Letter Report  
on  
Review and Evaluation  
of the  
Indian Point Probabilistic Safety Study

August 25, 1982

Sandia National Laboratories  
Albuquerque, New Mexico 87185

Reliability and Risk Assessment Branch  
Office of Nuclear Reactor Regulation  
U. S. Nuclear Regulatory Commission  
Washington, DC 20555

Figure 6 Effect of Including a Ramapo Fault Zone on Seismic-Caused Consequences

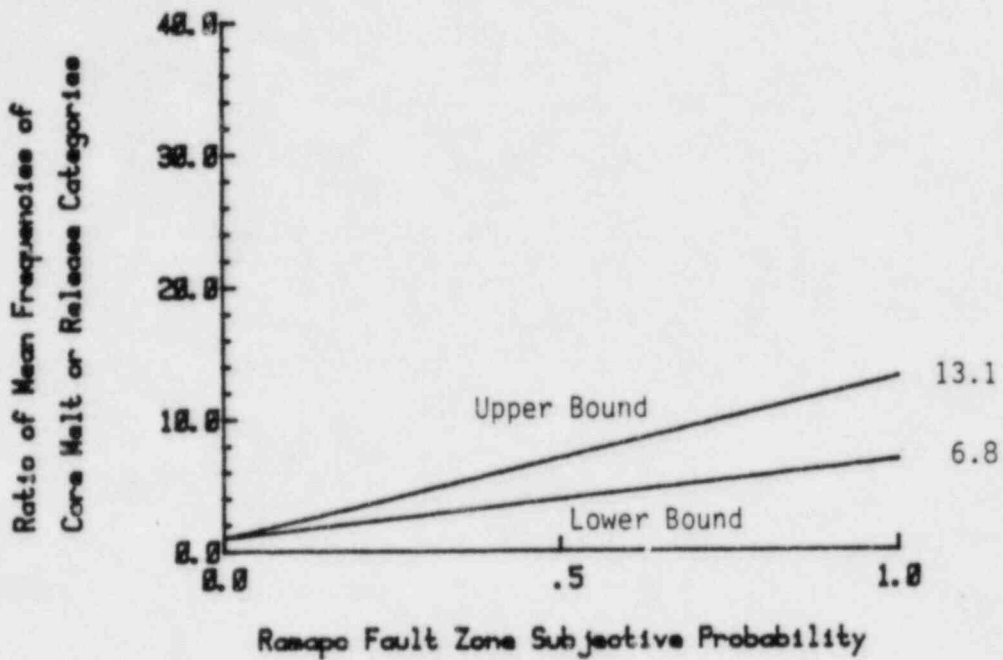
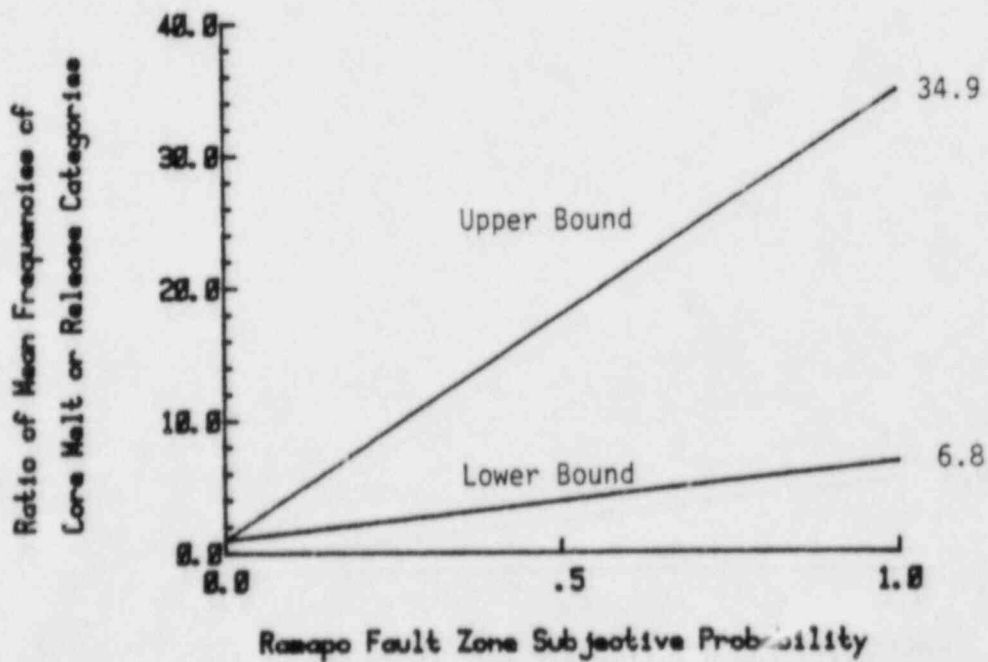
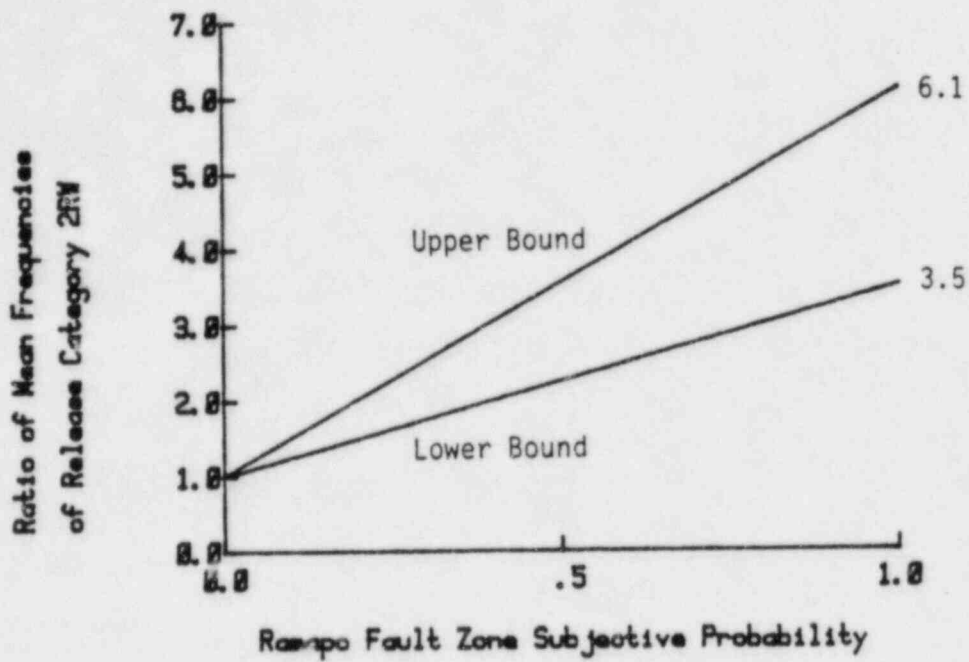
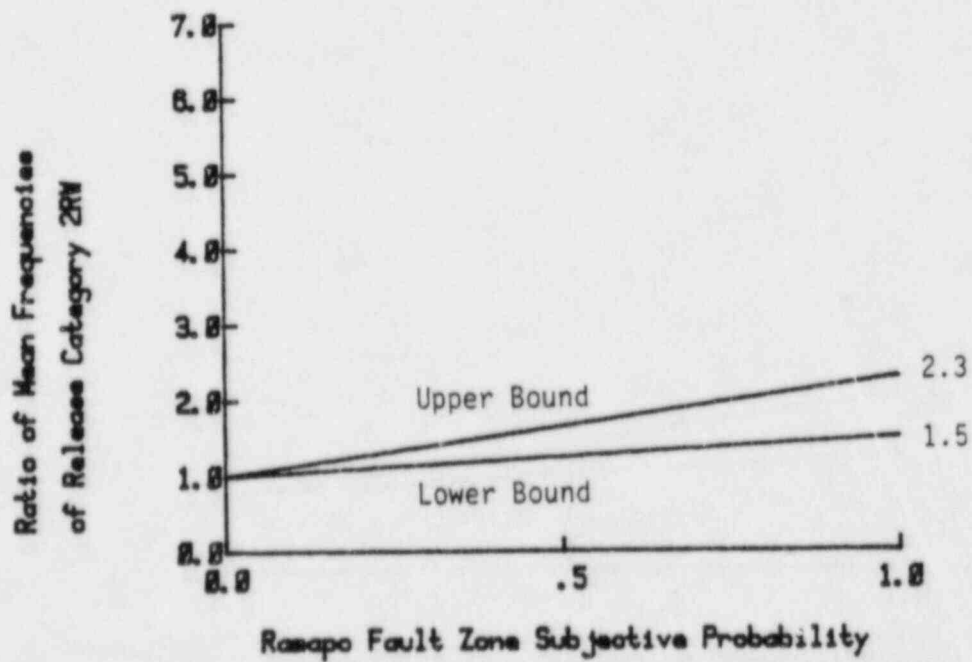
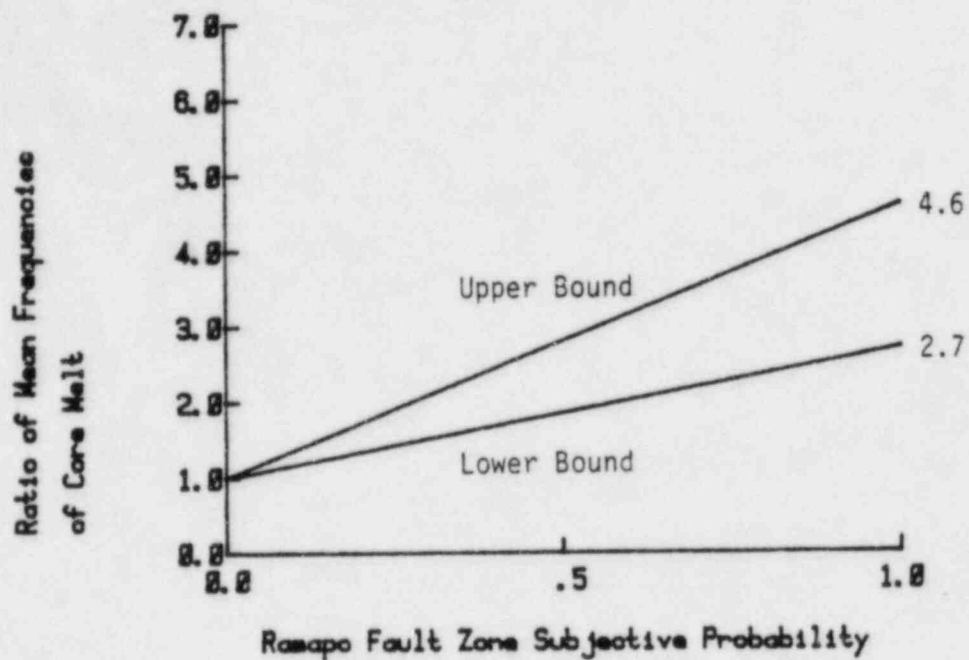
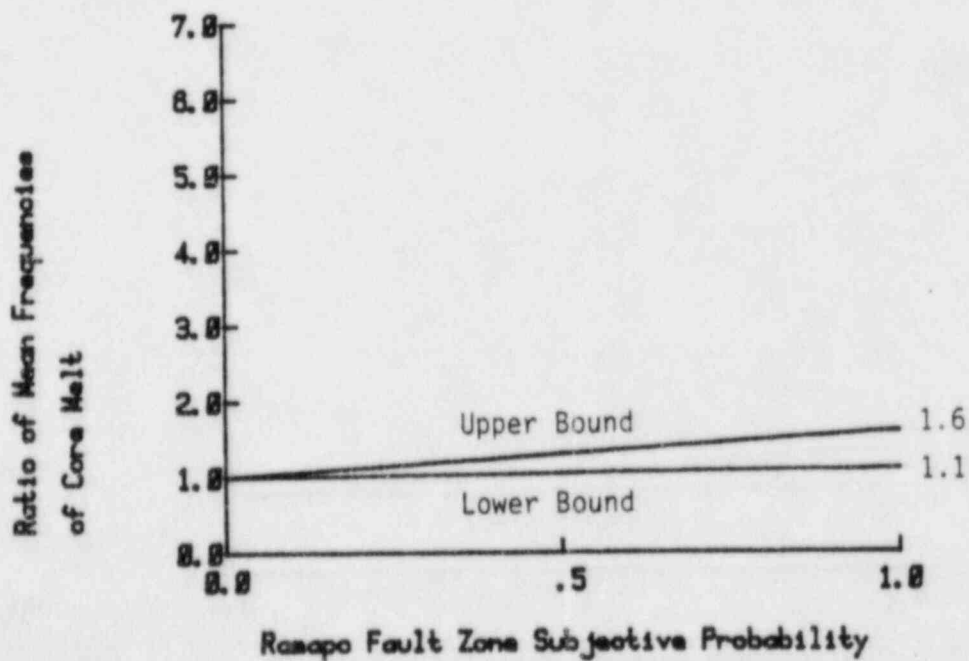
Figure 6 shows the effect of the Ramapo fault zone and its assumed background seismicity on the mean frequency of core melt or release categories for subjective probability values between 0 and 1. The curves were developed for release category 2RW. However, we expect the trend to be similar for other release categories and for core melt as well. Curves given for both Unit 2 and Unit 3 represent the ratio of the total seismicity-caused mean frequency (including the weighted contribution from the Ramapo source and background seismicity) to the seismically-caused mean frequency values corresponding to the IPPSS report (i.e.,  $1.4 \times 10^4$  per year for Unit 2 and  $2.4 \times 10^{-6}$  per year for Unit 3). Thus the results shown in Figure 6 pertain only to seismically-caused consequences.

Figures 7 and 8 show similar plots for total mean frequency of release category 2RW and core melt, respectively. In these plots the mean frequency values given in IPPSS report Tables 8.3-2 and 8.3-3 were used as the base values for Unit 2 and Unit 3, respectively. Thus the effect of the Ramapo fault zone on higher level consequences as function of the subjective probability for the zone can be seen.
